Submission form - Stapletons Road renewal Results

Stapletons Road Renewal

Submission from Spokes Canterbury

#Submission 45757

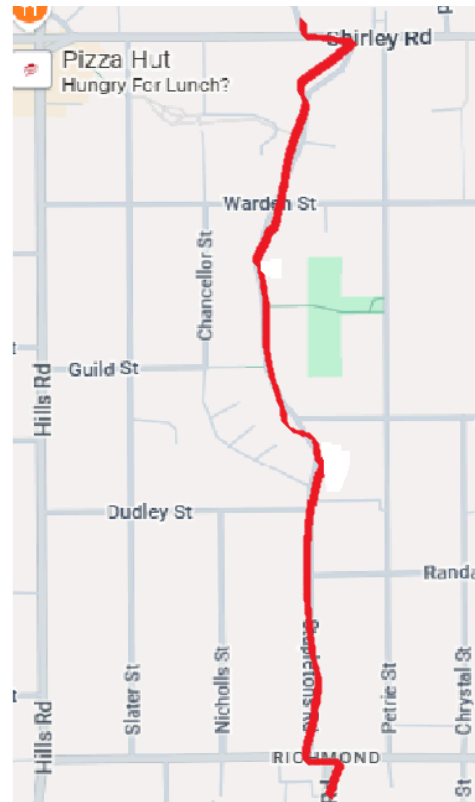
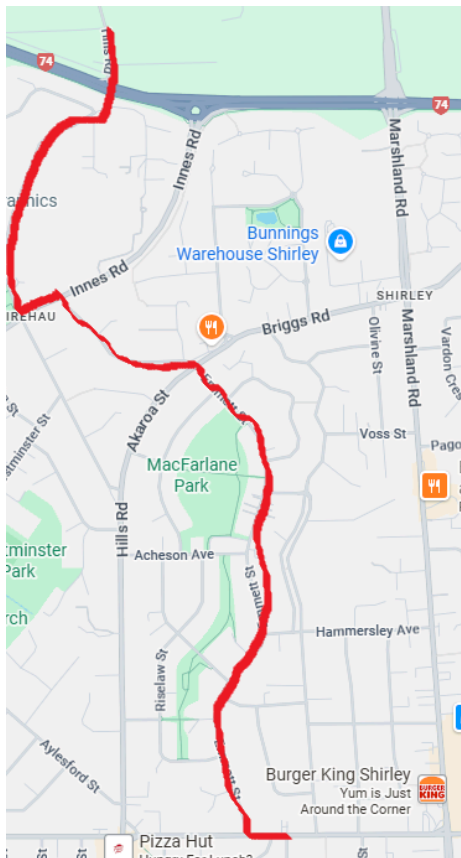
We believe this project does not address the significant issues at the Stapletons Road / North Avon Road / Stanmore Road intersection. The consultation indicated that some issues with “unsafe turning movements” at the intersection be addressed separately but it was not clear if these are the same issues that concern Spokes.

- Cyclists are coming across the lights from Stanmore Road onto the footpath to get into Stapletons Road as it is safer and there is no way to turn right off North Avon Road. The path is relatively narrow and it is difficult to see if someone is coming the other way. The vegetation is often overgrown which does not help. As the footpath cannot be widened due to the cost of moving the powerpole and the lights control box together with the closeness of private property, the best option is to create a specific cycle path on the west side of the lights control box to avoid conflict with pedestrians.

- Vehicles turning left out of Stapletons Road are encroaching into the cycle lane on North Avon Road using it as an illegal third lane on North Avon Road to get into the traffic. Vehicles are often banked up in the straight through lane and the right turn into Stanmore Road. Some flexi-posts would help make it safer for cyclists.
